Camelback Spring Cap, Modification CHU, CXU, GU, TD, LEU, MRU

FSB 722-002, Camelback Spring Cap, Modification

(March 2014)

W7088547

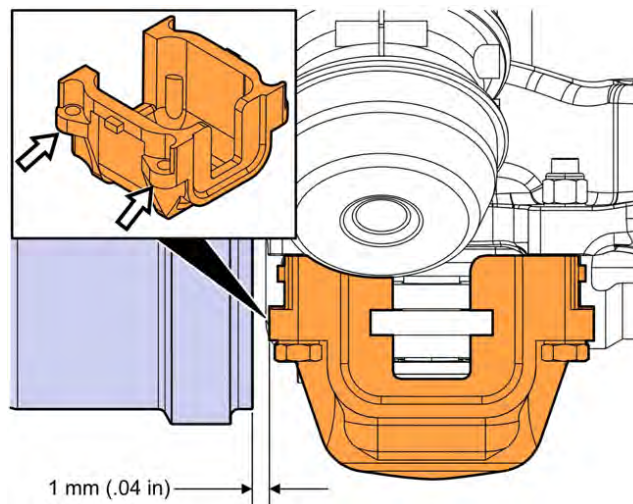
- 6 Inspect each of the rear wheel ends for interference between the brake lining and the spring cap.

Note: A clearance of 1 mm (.04 in) between the brake lining and the spring cap passes inspection.

Note: A clearance of less than 1 mm (.04 in) between the brake lining and the spring cap fails inspection.

W7088552

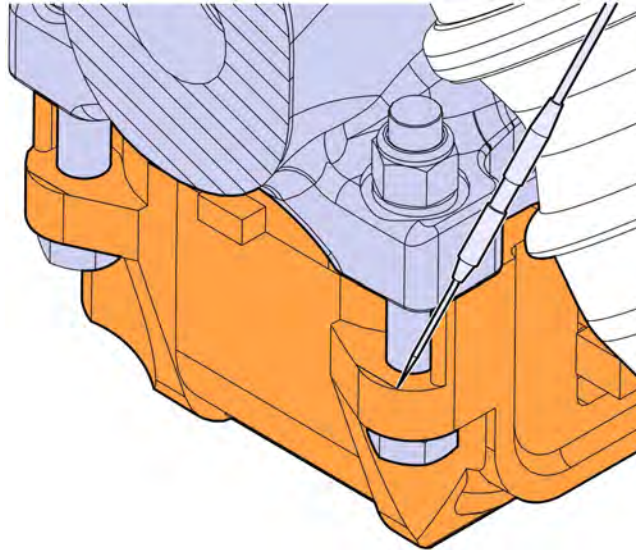
- 7 Measure 4 mm (0.16 in) from the edge of the spring cap towards the center of the axle housing.

W7088553

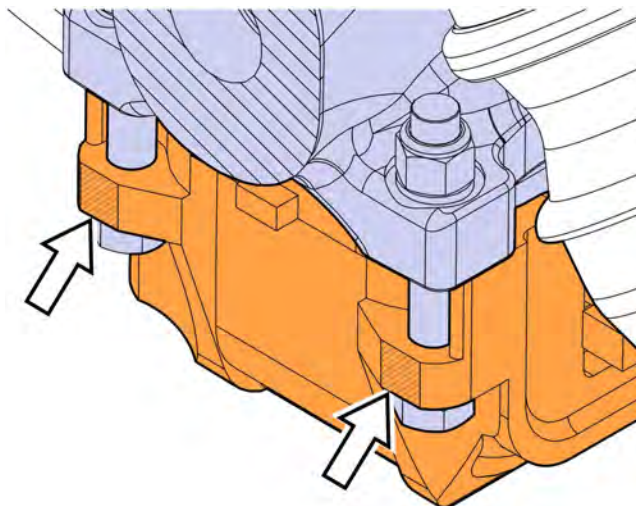
- 8 Scribe a line at the distance of 4 mm (0.16 in) from the edge of the spring cap boss.

W7088554

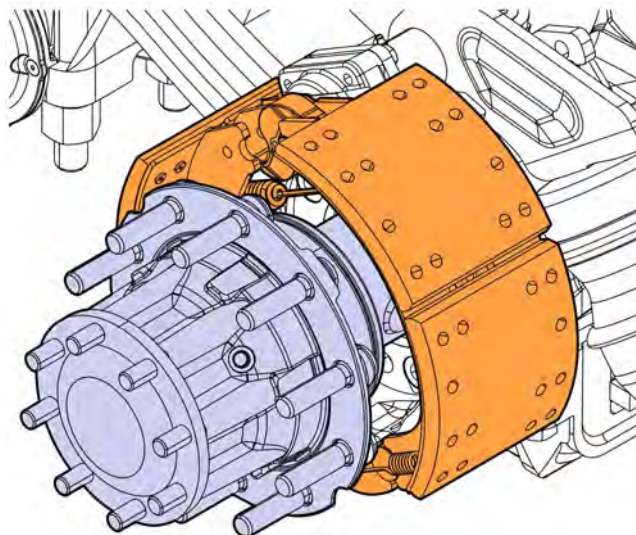
- 9 Grind no more than 4 mm (0.16 in) of material from the spring cap boss.

Grinding excessive material from the spring cap boss may result in a later failure due to a weakened spring cap.

- 10 Apply paint to the bare metal area of the spring cap boss to protect it from rust.
